Groundwater Application Review Summary Form

Application # G- 19002

GW Reviewer Travis Brown / Aurora C Bouchier Date Review Completed: 8/12/2021

TO: Water Rights Section Date 8/12/2021
 FROM: Groundwater Section Travis Brown / Aurora C Bouchier
 Reviewer's Name
 SUBJECT: Application G- 19002 Supersedes review of 12/1/2020
 Date of Review(s)

Stream Depletion: Well 1 to Willamette River

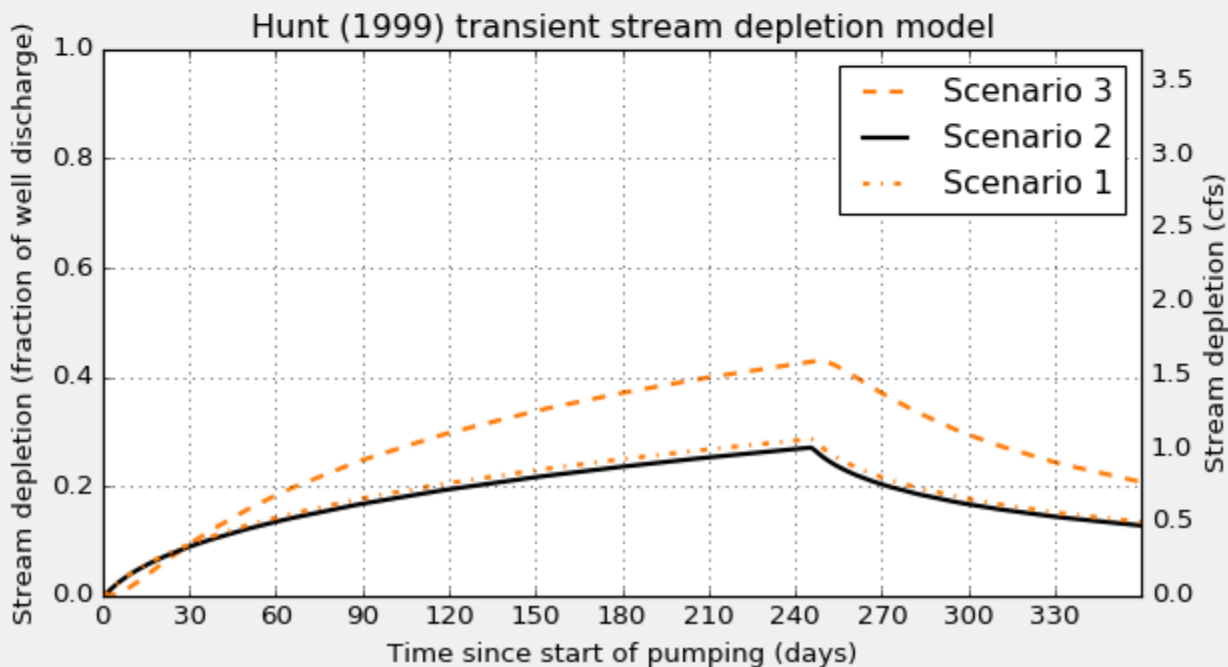
Application type:	G
Application number:	19002
Well number:	1
Stream Number:	1
Pumping rate (cfs):	3.71
Pumping duration (days):	245
Pumping start month number (3=March)	3.0

Parameter	Symbol	Scenario 1	Scenario 2	Scenario 3	Units
Distance from well to stream	a	2340	2340	2340	ft
Aquifer transmissivity	T	2000	24000	24000	ft ² /day
Aquifer storativity	S	0.002	0.02	0.20	-
Aquitard vertical hydraulic conductivity	Kva	0.01	0.1	1	ft/day
Not used		20.0	20.0	20.0	
Aquitard thickness below stream	babs	40	40	40	ft
Not used		0.2	0.2	0.2	
Stream width	ws	400	400	400	ft

Days	10	330	360	30	60	90	120	150	180	210	240	270	300
Depletion (%)	4	14	13	9	13	17	19	22	24	25	27	20	17
Depletion (cfs)	0.15	0.53	0.47	0.33	0.50	0.62	0.72	0.80	0.87	0.94	0.99	0.75	0.62

Stream Depletion: Well 1 to Unnamed Slough

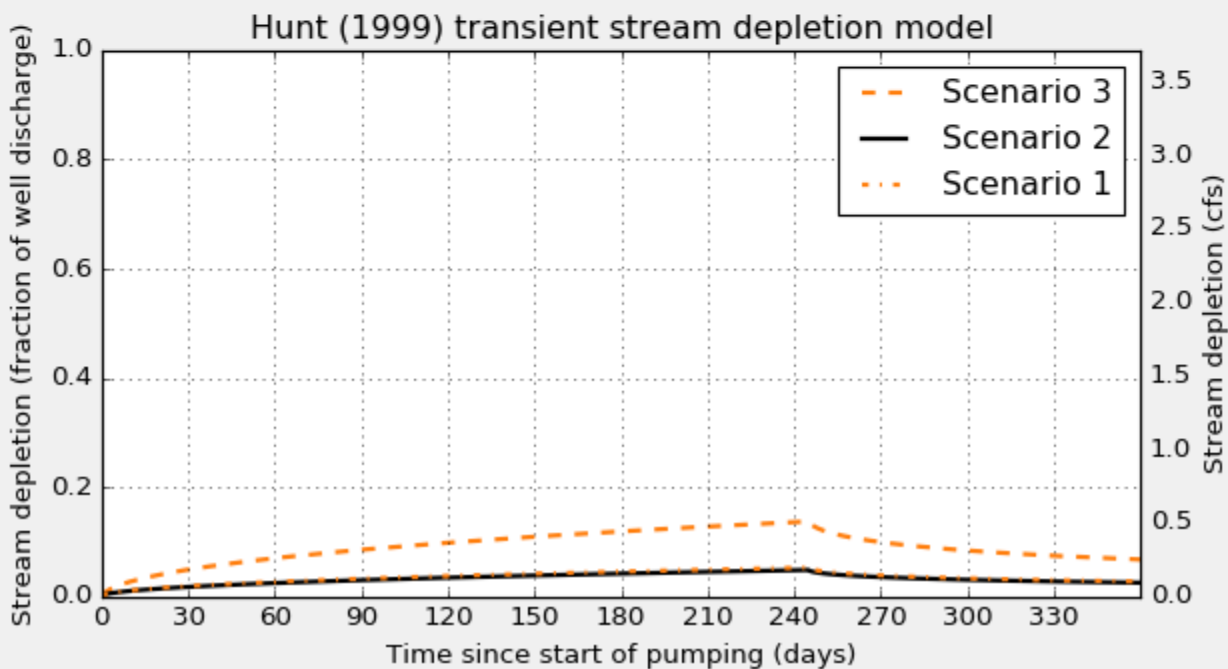
Application type:	G
Application number:	19002
Well number:	1
Stream Number:	2
Pumping rate (cfs):	3.71
Pumping duration (days):	245
Pumping start month number (3=March)	3.0

Parameter	Symbol	Scenario 1	Scenario 2	Scenario 3	Units
Distance from well to stream	a	200	200	200	ft
Aquifer transmissivity	T	2000	24000	24000	ft ² /day
Aquifer storativity	S	0.002	0.02	0.2	-
Aquitard vertical hydraulic conductivity	Kva	0.01	0.1	1	ft/day
Not used		20	20	20	
Aquitard thickness below stream	babs	40	40	40	ft
Not used		0.2	0.2	0.2	
Stream width	ws	50	50	50	ft

Days	10	330	360	30	60	90	120	150	180	210	240	270	300
Depletion (%)	1	3	2	2	2	3	3	4	4	4	5	3	3
Depletion (cfs)	0.04	0.10	0.09	0.06	0.09	0.11	0.13	0.14	0.15	0.17	0.18	0.13	0.11

Stream Depletion: Well 2 to Willamette River

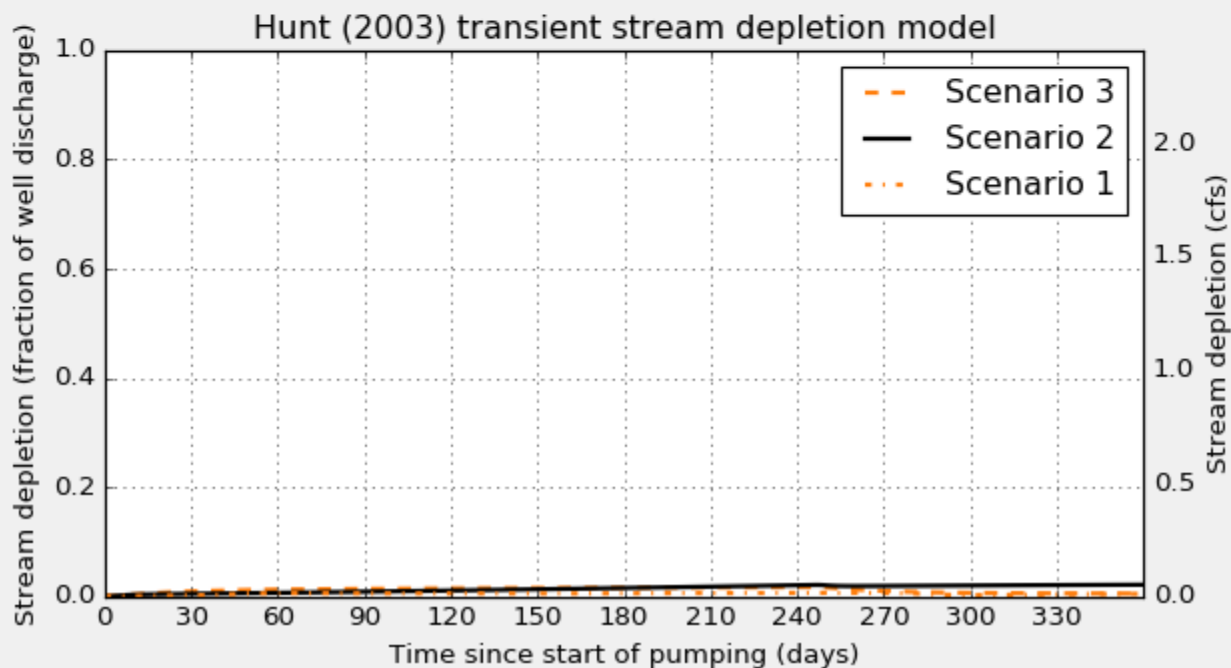
Application type:	G
Application number:	19002
Well number:	4
Stream Number:	1
Pumping rate (cfs):	2.41
Pumping duration (days):	245
Pumping start month number (3=March)	3.0

Parameter	Symbol	Scenario 1	Scenario 2	Scenario 3	Units
Distance from well to stream	a	4120	4120	4120	ft
Aquifer transmissivity	T	600	2100	6600	ft ² /day
Aquifer storativity	S	.001	.005	.01	-
Aquitard vertical hydraulic conductivity	Kva	.1	.05	.01	ft/day
Aquitard saturated thickness	ba	30	30	30	ft
Aquitard thickness below stream	babs	40	40	40	ft
Aquitard specific yield	Sya	0.2	0.2	0.2	-
Stream width	ws	400	400	400	ft

Days	10	330	360	30	60	90	120	150	180	210	240	270	300
Depletion (%)	0	2	2	0	1	1	1	1	1	2	2	2	2
Depletion (cfs)	0.01	0.05	0.05	0.01	0.01	0.02	0.02	0.03	0.04	0.04	0.05	0.05	0.05

Stream Depletion: Well 3 to Willamette River

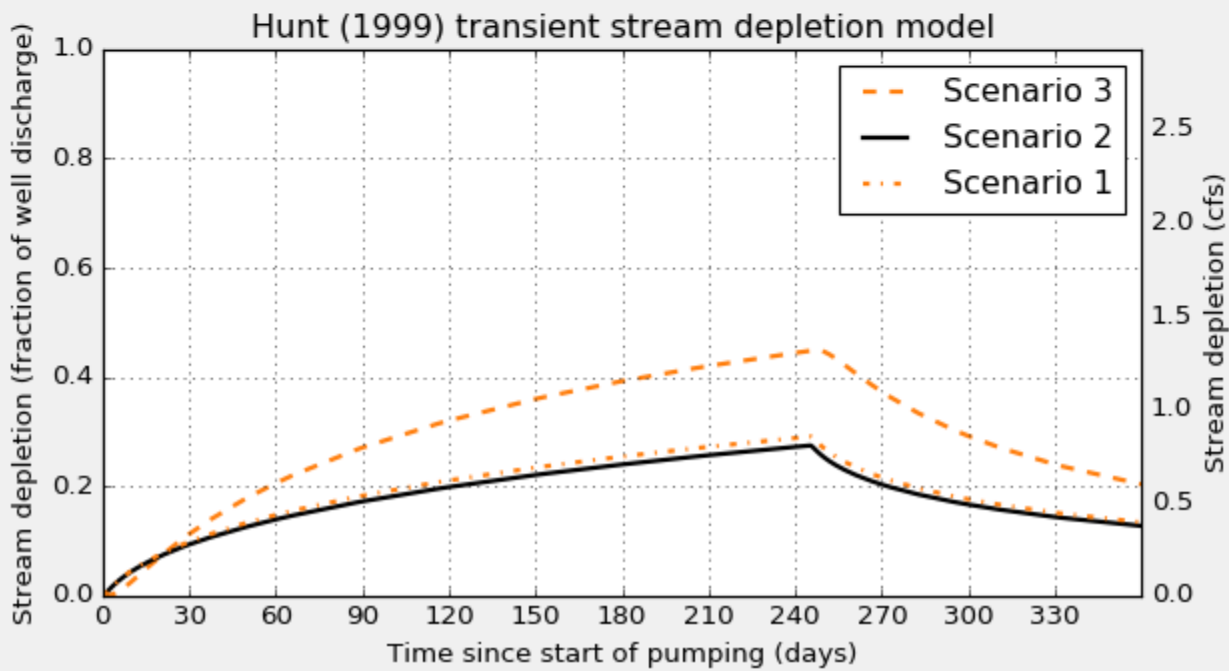
Application type:	G
Application number:	19002
Well number:	3
Stream Number:	1
Pumping rate (cfs):	2.93
Pumping duration (days):	245
Pumping start month number (3=March)	3.0

Parameter	Symbol	Scenario 1	Scenario 2	Scenario 3	Units
Distance from well to stream	a	2050	2050	2050	ft
Aquifer transmissivity	T	2000	24000	24000	ft ² /day
Aquifer storativity	S	0.002	0.02	0.20	-
Aquitard vertical hydraulic conductivity	Kva	0.01	0.1	1	ft/day
Not used		20.0	20.0	20.0	
Aquitard thickness below stream	babs	40	40	40	ft
Not used		0.2	0.2	0.2	
Stream width	ws	400	400	400	ft

Days	10	30	60	90	120	150	180	210	240	270	300	330
Depletion (%)	4	14	13	9	14	17	20	22	24	26	27	20
Depletion (cfs)	0.13	0.42	0.37	0.27	0.41	0.50	0.58	0.65	0.70	0.75	0.80	0.59

Stream Depletion: Well 3 to Unnamed Slough

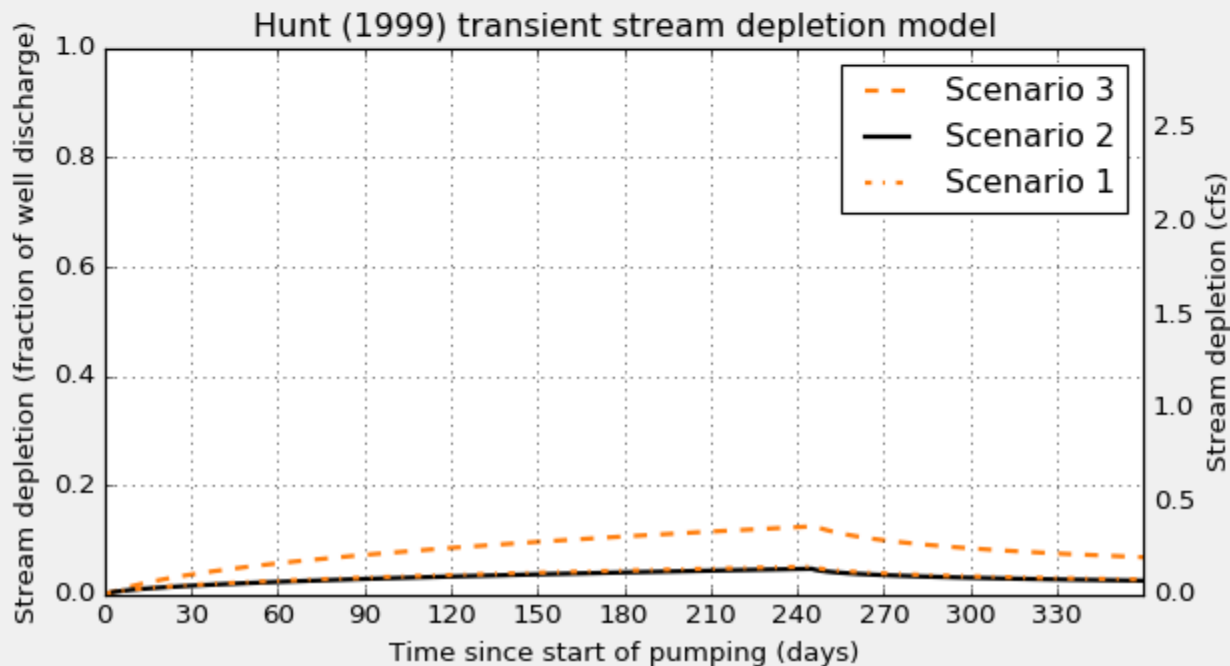
Application type:	G
Application number:	19002
Well number:	3
Stream Number:	2
Pumping rate (cfs):	2.93
Pumping duration (days):	245
Pumping start month number (3=March)	3.0

Parameter	Symbol	Scenario 1	Scenario 2	Scenario 3	Units
Distance from well to stream	a	800	800	800	ft
Aquifer transmissivity	T	2000	24000	24000	ft ² /day
Aquifer storativity	S	0.002	0.02	0.2	-
Aquitard vertical hydraulic conductivity	Kva	0.01	0.1	1	ft/day
Not used		20	20	20	
Aquitard thickness below stream	babs	40	40	40	ft
Not used		0.2	0.2	0.2	
Stream width	ws	50	50	50	ft

Days	10	330	360	30	60	90	120	150	180	210	240	270	300
Depletion (%)	1	3	2	2	2	3	3	4	4	4	5	3	3
Depletion (cfs)	0.02	0.08	0.07	0.05	0.07	0.08	0.09	0.11	0.12	0.13	0.13	0.10	0.09

Well 1, MARI 2892

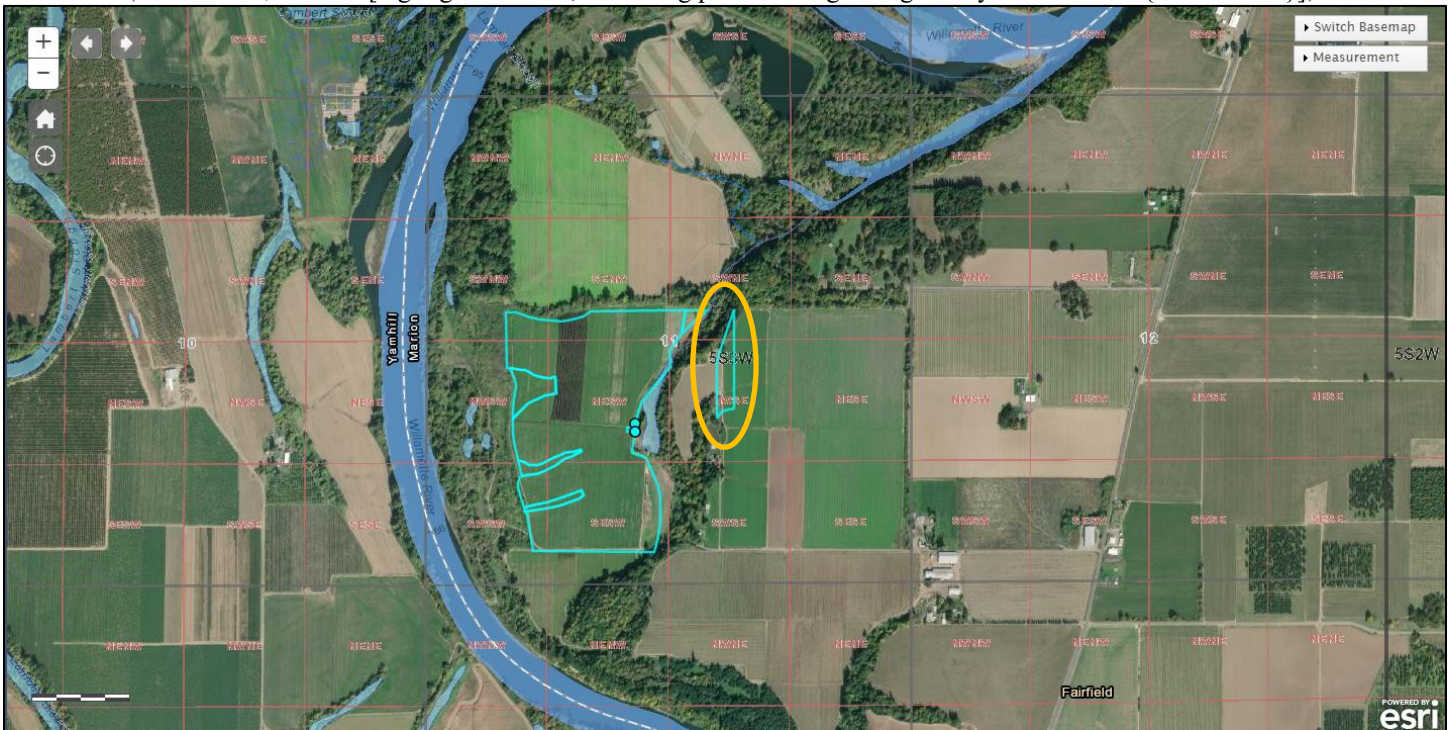
Well 1 (MARI 2892) is authorized for 1.44 cfs for irrigation of 114.9 acres under Certificate 43676 owned by Opal M Mahony. It appears that the 114.9 acres irrigated under Certificate 43676 are proposed as nursery use from wells 1 & 2 under this application. Well 1 is also authorized for 0.04 cfs for irrigation of 9.5 acres under Certificate 75639 owned by Michael W Mahony. This groundwater review evaluates against a stacked rate of 3.71 cfs.

Cert 43676 (only POD, IR 114.9 acres, 1.44 cfs, apparent overlap with current application highlighted)

Well 2, MARI 2900

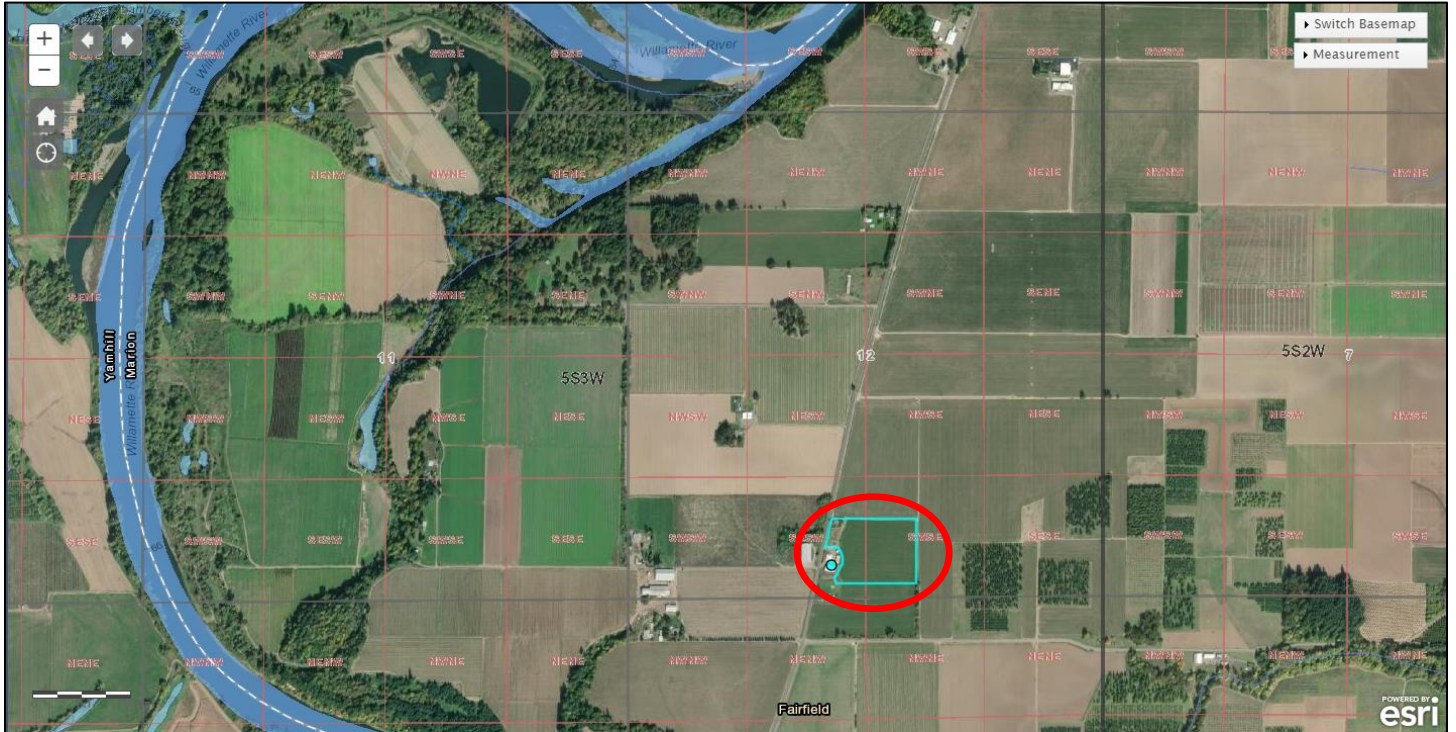
Well 2 (MARI 2900) is authorized for 0.18 cfs for irrigation of 14.2 acres under Certificate 55955 owned by John Stockfleth. It appears that the 14.2 acres irrigated under Certificate 55955 are proposed as nursery use from wells 1 & 2 under this application. This groundwater review evaluates against a stacked rate of 2.41 cfs.

Cert 55955 (only POD, IR 14.2 acres, 0.18 cfs, apparent overlap with current application highlighted)

Well 3, MARI 2890

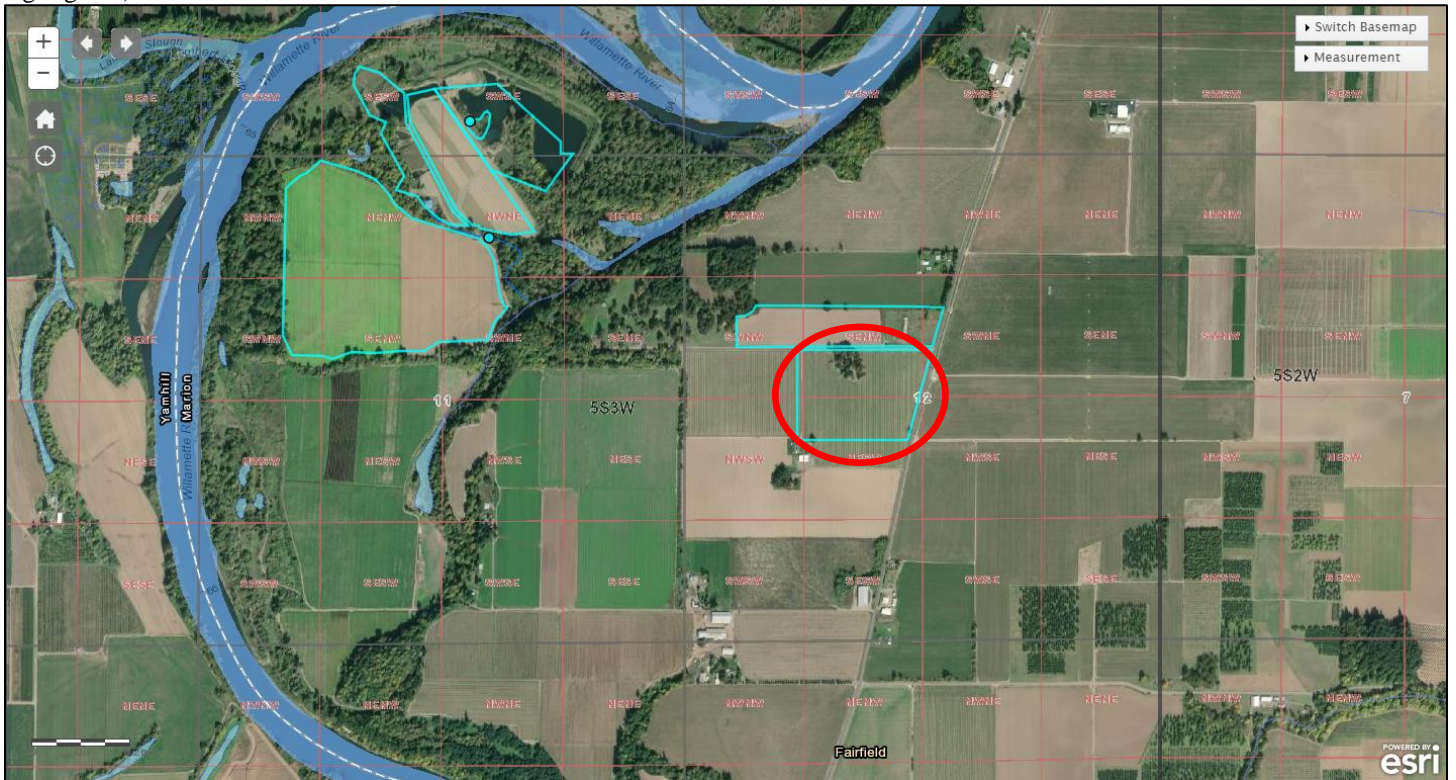
Well 3 (MARI 2890) is authorized for 2.16 cfs for irrigation of 172.6 acres under Permit G-11145 owned by Gerald A Baker. It appears that up to 30.2 acres irrigated under Permit G-11145 are proposed for irrigation from Well 3 under this application. This groundwater review evaluates against a stacked rate of 2.93 cfs. In November 2019, a pump test was rejected for this water right as it only measured the water level to the nearest foot. A new test has been submitted, although it has not yet been analyzed.

Permit G-11145 (IR 172.6 acres, 2.16 cfs, also a sump with different rate for industrial uses, apparent overlap with current application highlighted)
